### **PLANNING COMMISSION**

**Monday, December 15, 2025, 5:00 P.M.**

**Sketch Plan approval for development  
of a Free-Standing Emergency  
Department (FSED) & Patient-Care  
Center (PCC)  
by Novant Health**

# STAFF REPORT: PLANNING COMMISSION (PC) – SKETCH PLAN

**SHEET L100**

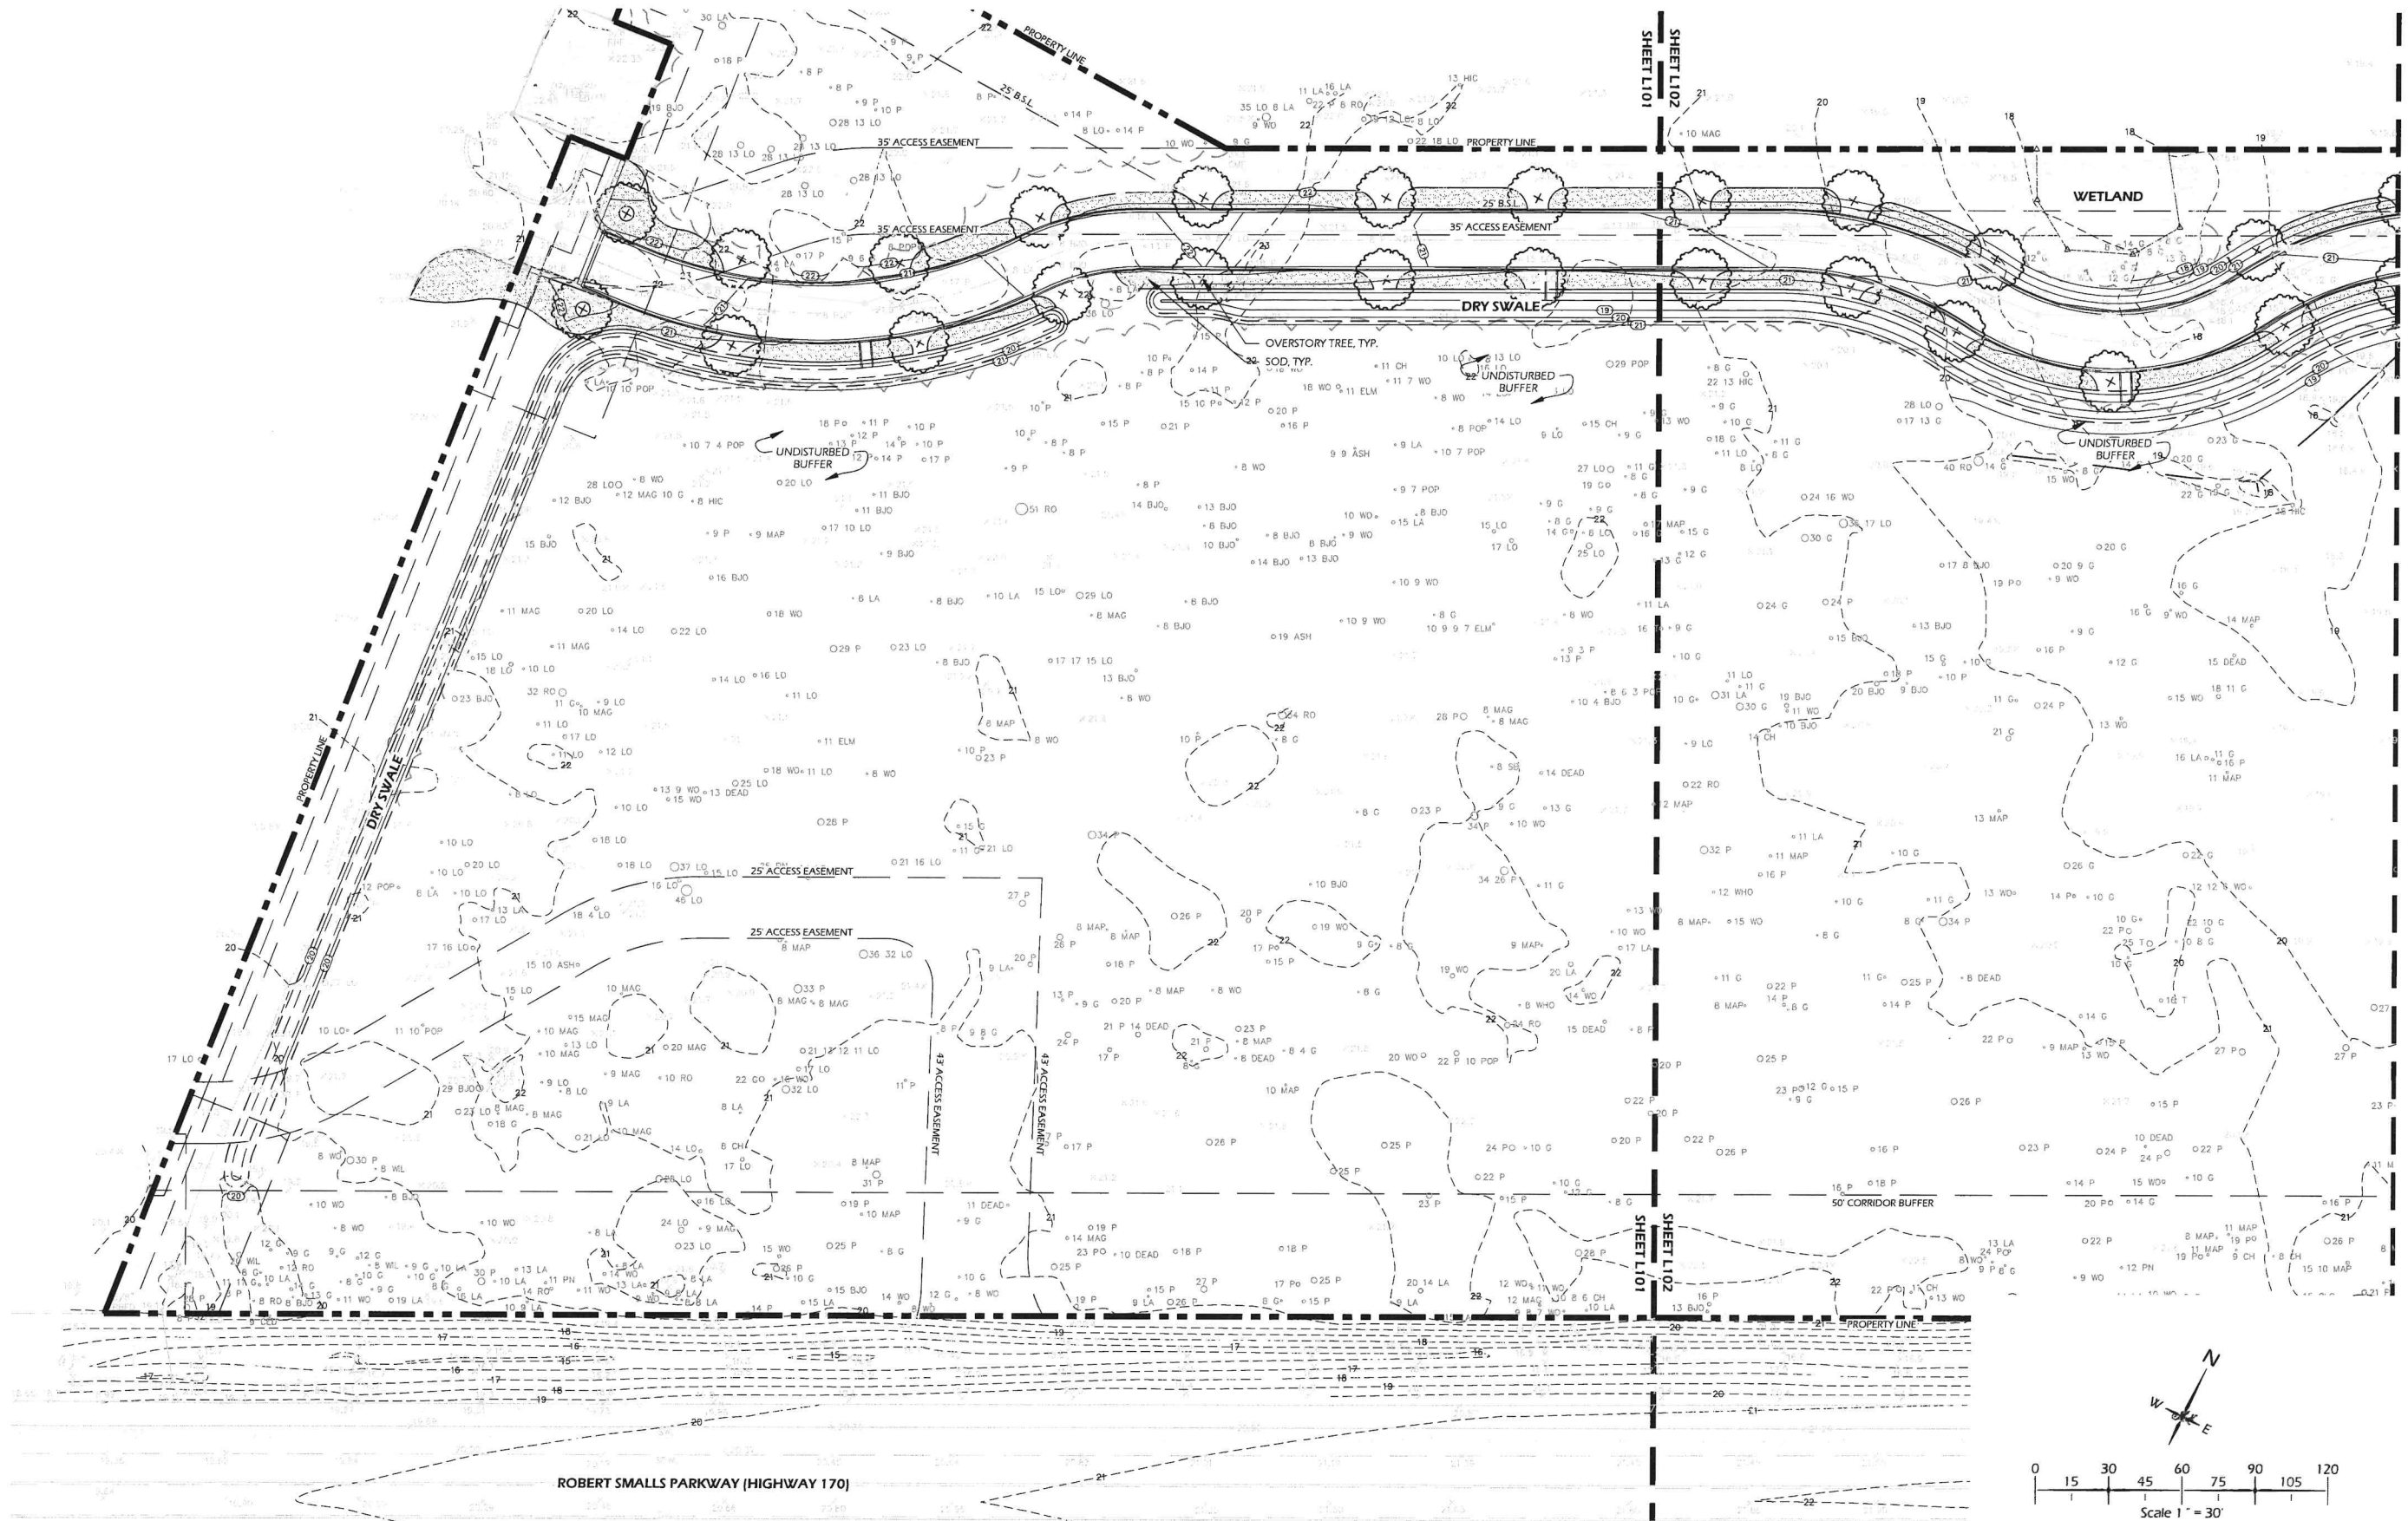
- **Scaling, massing and building designs do not meet Comprehensive Plan, Civic Master Plan or Beaufort Development Code expectations for this location.**

- ❖ **Demonstrate how the remainder of the parcel will be developed and made accessible, including street connectivity; pedestrian / bike trail connections; type and placement of specific uses, and/or the concept of how the overall property development will fit into the surrounding development pattern and community along the Robert Smalls Parkway corridor; refer to all Sketch Plan elements in accordance with Code Sec. 7.5.3.B, which are: 1. Street Plan / Proposed street network, inter-connectivity (see staff analysis, page 2); 2. Open Space Plan to show which type of (active) community green / open spaces are provided for and where (see staff analysis, page 3); 3. Pedestrian Network, including better provision of inter-connectivity of sidewalks and trails for both pedestrians and cyclists (see staff analysis, page 4); and Sketch Plan Review Criteria pursuant to Code Sec. 7.5.3.F: The conceptual design and massing proposed (see staff analysis, page 7).**

SHEET L103

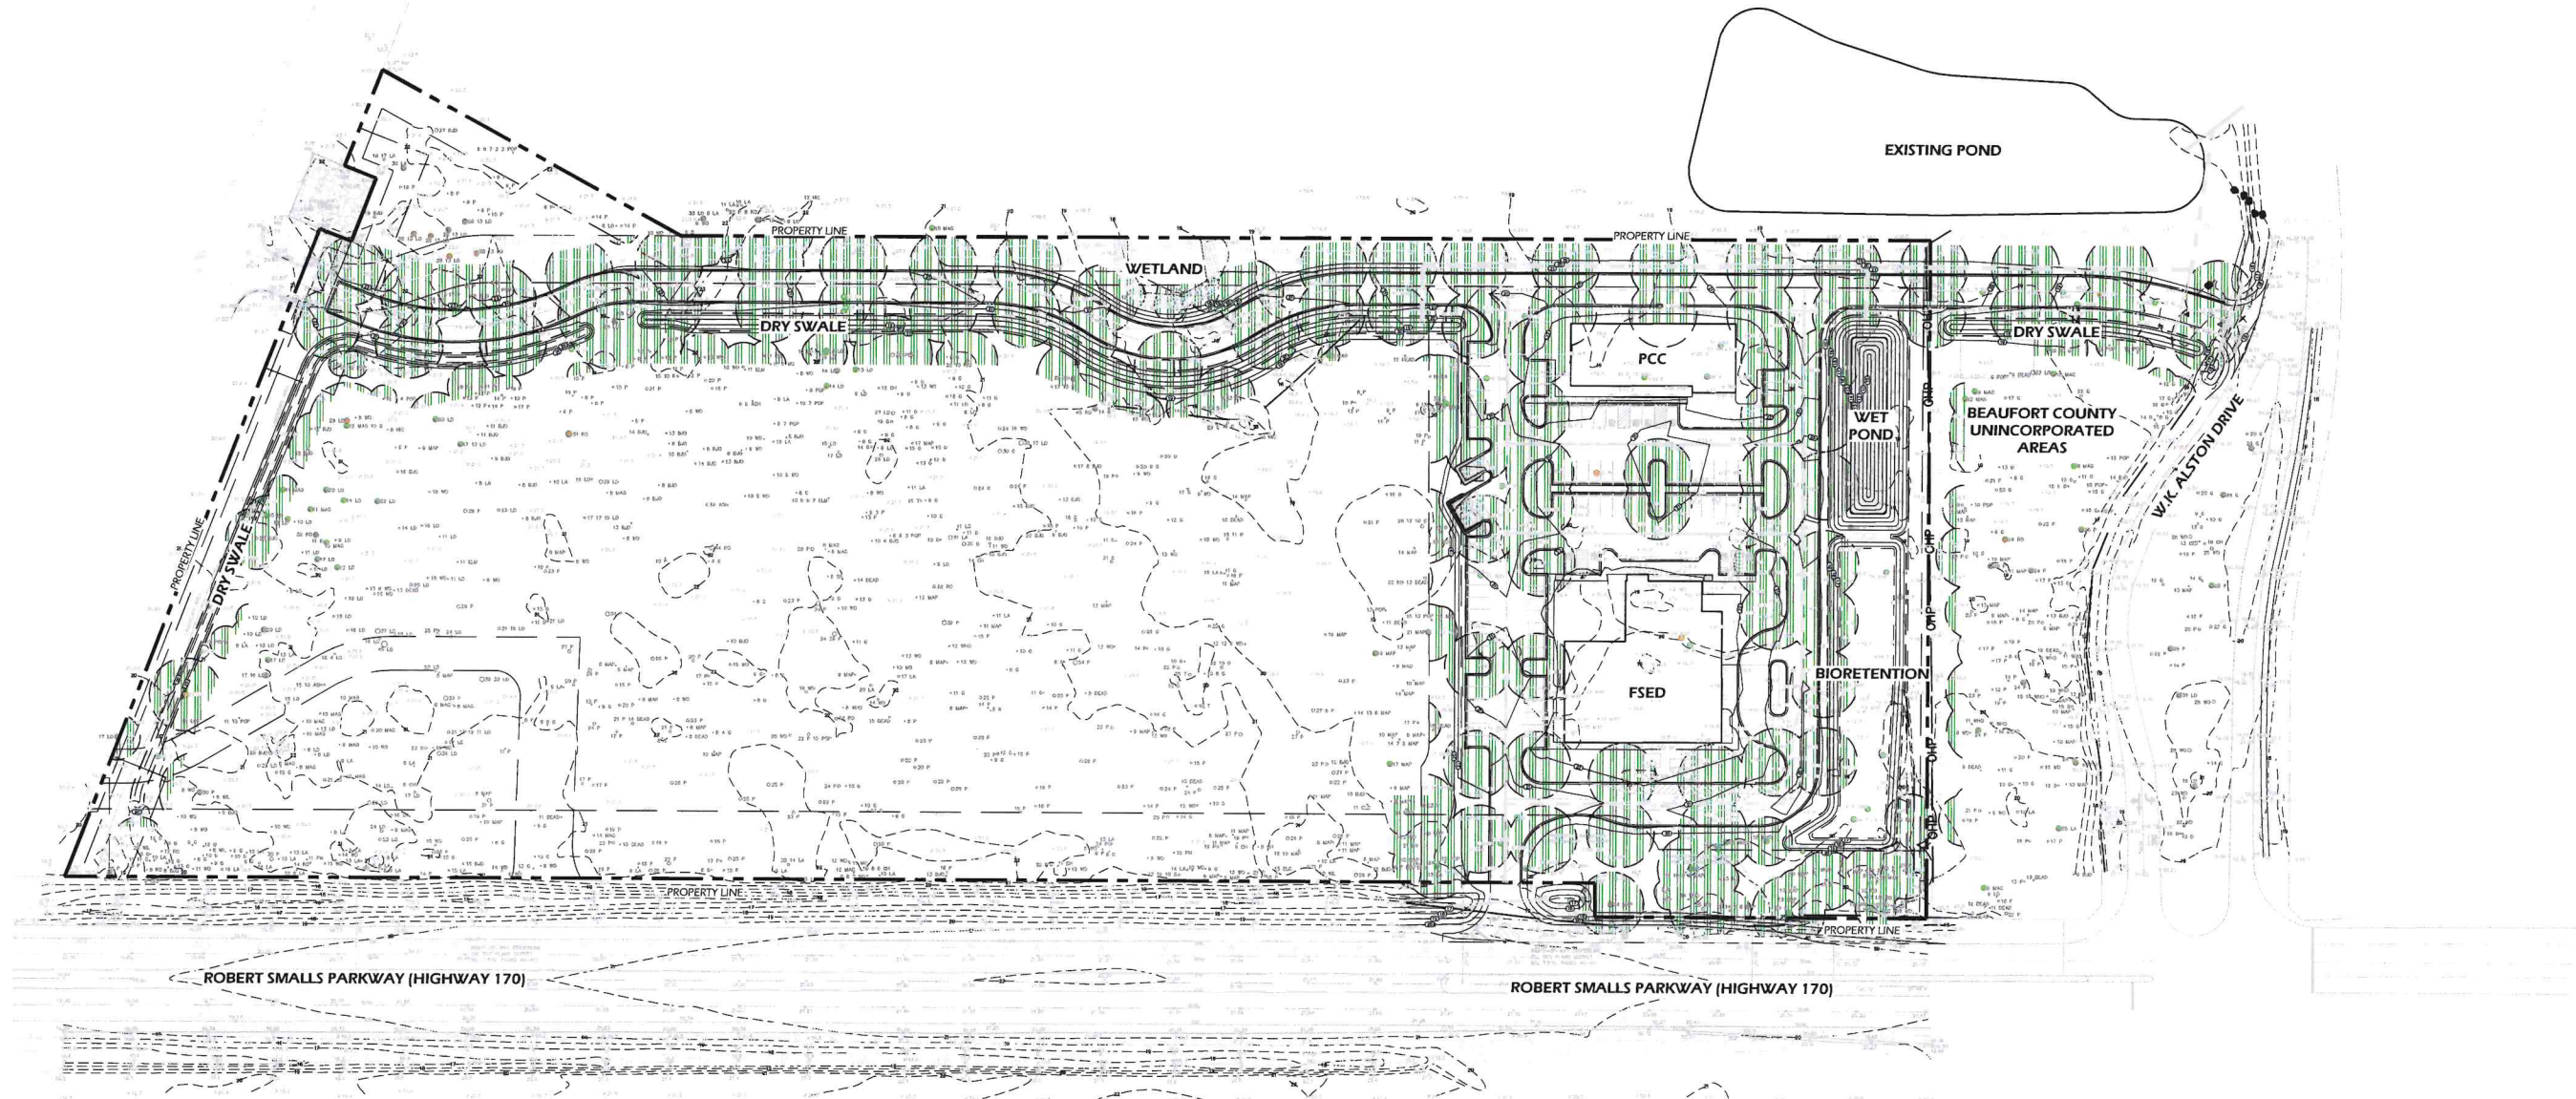
1. Provide erosion and sediment control bmps to protect the swale within this area adjacent to Robert Smalls Park Way. **Comment addressed. Additional silt fence, sediment tubes, temporary and permanent seeding, and riprap have been added to provide erosion and sediment control. See sheet C202 / C802**
2. Depict a temporary culvert under the construction entrance in Phase 1 so that it can span the existing ditch. **Comment addressed, see on Sheet C202.**
